# Design Change Notification

Product: BLDC FAN MOTOR

Model: San Ace 172 9L type

SANYO DENKI CO., LTD.  
Design Dept., Cooling Systems Div.

**[Attached Sheet #2]**

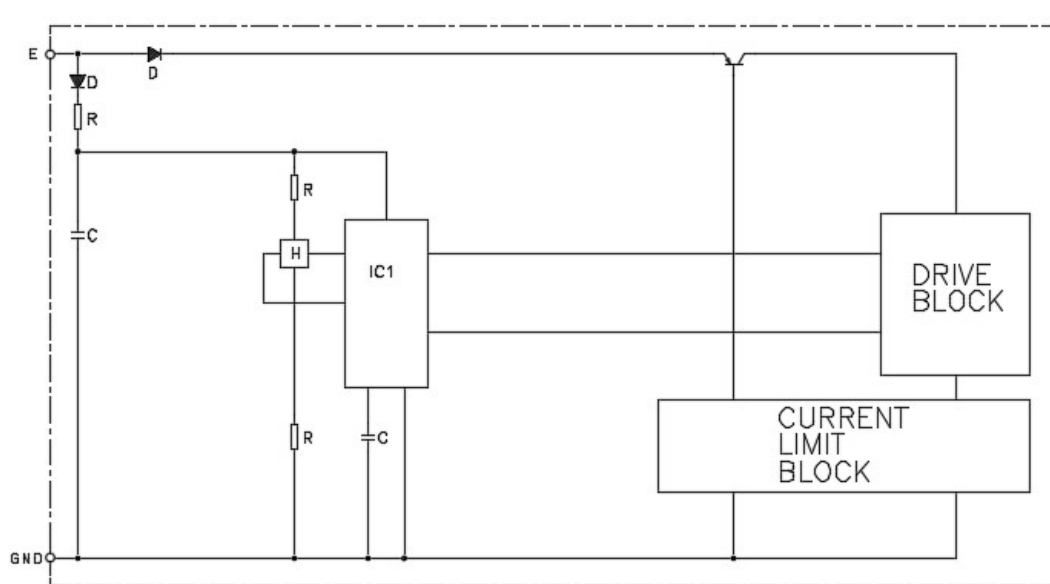
MODEL	Current Design	Modification
Motor	109L5712H5xx, 109L5712H5Dxx 109L1712H5xx, 109L1712H5Dxx	$\phi 0.5 \times 86$ turns	$\phi 0.5 \times 96$ turns
	109L5712M5xx, 109L5712M5Dxx 109L1712M5xx, 109L1712M5Dxx	$\phi 0.45 \times 125$ turns	$\phi 0.4 \times 180$ turns
Starting current	109L5712H5xx, 109L5712H5Dxx 109L1712H5xx, 109L1712H5Dxx	Nom.: 2.7A Max.: 3.0A	Nom.: 2.85A Max.: 3.45A

Schematic circuit diagram before change

Schematic circuit diagram after change

**[Attached Sheet #3]**

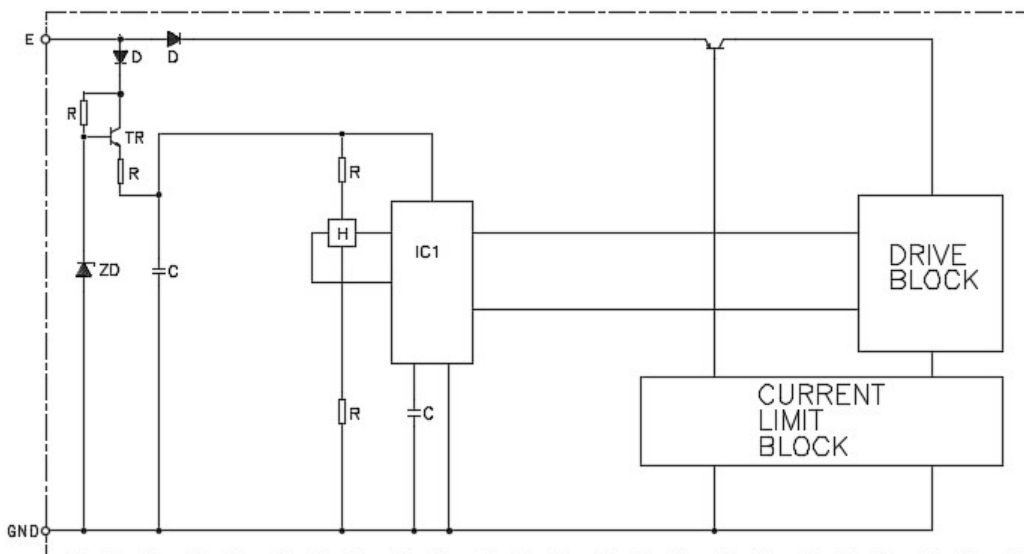
MODEL	Current Design	Modification
Motor	109L5724H5xx, 109L5724H5Dxx 109L1724H5xx, 109L1724H5Dxx	$\phi 0.35 \times 180$ turns	$\phi 0.35 \times 190$ turns
	109L5724M5xx, 109L5724M5Dxx 109L1724M5xx, 109L1724M5Dxx	$\phi 0.3 \times 295$ turns	$\phi 0.29 \times 335$ turns

Schematic circuit diagram before change

Schematic circuit diagram after change
